**From:** Richard James <rickjames@e-coustic.com>  
**Sent:** Monday, March 03, 2014 3:12 PM  
**To:** Hingtgen, Robert J  
**Cc:** 'Donna Tisdale'; 'svolker'  
**Subject:** Comments on Soitec Solar Development Draft Program Environmental Impact Report (DPEIR)  
**Attachments:** 14-03-03 Comments on Soitec Solar Development.pdf

**Re: Comments on Soitec Solar Development Draft Program Environmental Impact Report (DPEIR) : 3800 12-010; Tierra Del Sol, 3300 12-010 (MUP), 3600 12-005 (REZ), 3921 77-046-01 (AP); Rugged Solar, 3300 12-007 (MUP); Environmental LOG NO.: 3910 120005(ER)**

Community reaction to noise as a function of normalized CNEL values as calculated from case histories (after U.S. Environmental Protection Agency document NTID 300.3, *Community Noise*, 1971).

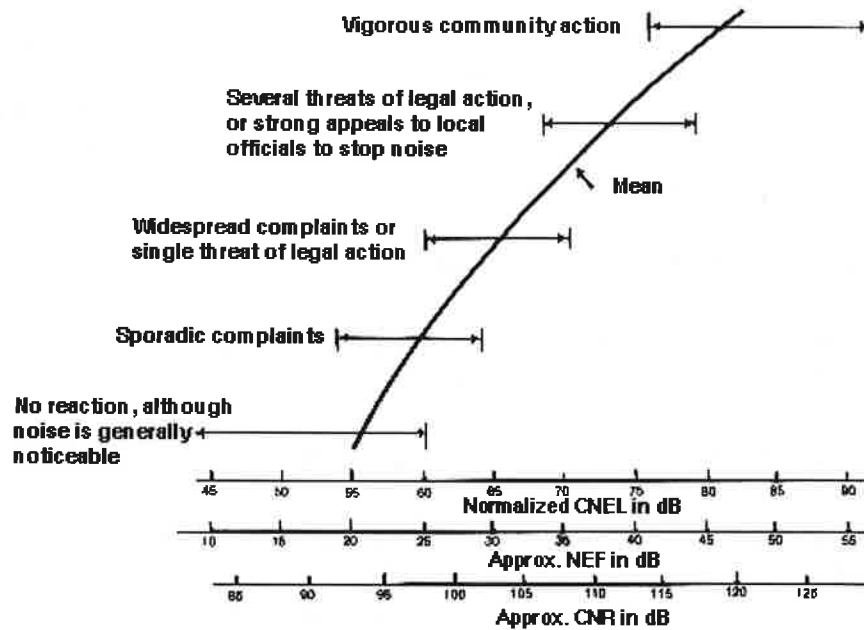
As stated above there is clear information in the EIR that some of the noise sources have tonal and/or impulsive characteristics. Proper application of the CNEL method requires that these characteristics be included in the calculations of the CNEL as a 5 dB penalty. See attachment to this document "CNEL Calculation and Normalization Methods" for these adjustments. The 5 dB adjustment for pure tones and impulses is found at the bottom of the table.

The CNEL method also requires an adjustment for the character of the community's soundscape prior to the Project. The Table for CNEL Calculations and Normalization Methods shows that for a community located remote from cities and from industrial activity and trucking an adjustment of +10 dB is required. Although there is some noise associated with Highway 8 traffic, the Project will be introducing more truck traffic from operation of the cement and rock crushing facility located in the Rugged Solar Project that will be on local roads and that may not follow a diurnal pattern. Just as there is no analysis of the impact of this additional traffic in the EIR Noise impact assessment the study also failed to consider these new noise sources that were not part of the pre-Project soundscape.
